ADDENDUM #1

NOTICE TO ALL BIDDERS FOR FREDERICK-WINCHESTER SERVICE AUTHORITY OPEQUON WATER RECLAMATION FACILITY

ITB #202008 -FOG FACILITY UPGRADES

HOSE REEL H-1 DETAIL

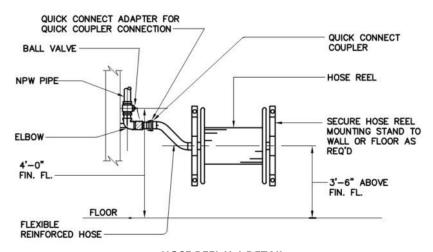
2.10 STAINLESS STEEL HOSE REEL (HR-1):

- A. Manual crank rewind with cam-lock brake and spring actuated pin lock
- B. inlet with stainless steel ball bearing swivel joint and 1-inch female NPT threads
- C. Heavy duty stainless steel angle mounting bracket
- D. Storage for up to 75 feet of 3/4" I.D. hose
- E. Unit shall be by Steel Eagle, Hannay Reels, Inc., or Reelcraft,
- F. Provide 75- feet 3/4" I.D. hose

Drawing M103 Revisions

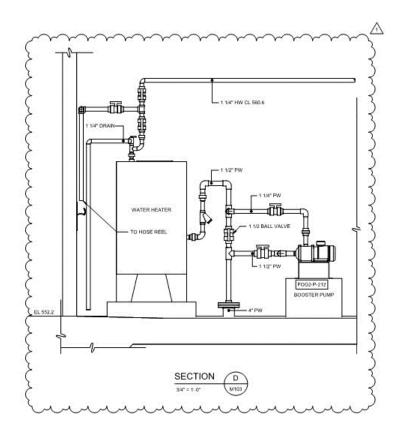
- 1. **Revise** Drawing M103 as shown in the attachments herein.
- 2. **Revise** Drawing M107 as shown in the attachments herein.
- 3. Drawing E7, **Delete** Note 1 in its entirety and **Add** Note "1 REMOVE EXISTING 225A BREAKER AND PROVIDE NEW 600A BREAKER TO POWER PP-FOG2.
- 4. Drawing E6, Revise MPZ-FOG2 and PP-FOG2 Panel Schedules to Indicate NEMA 4X rating
- 5. **Revise** Drawing E7 as shown in the attachments herein.
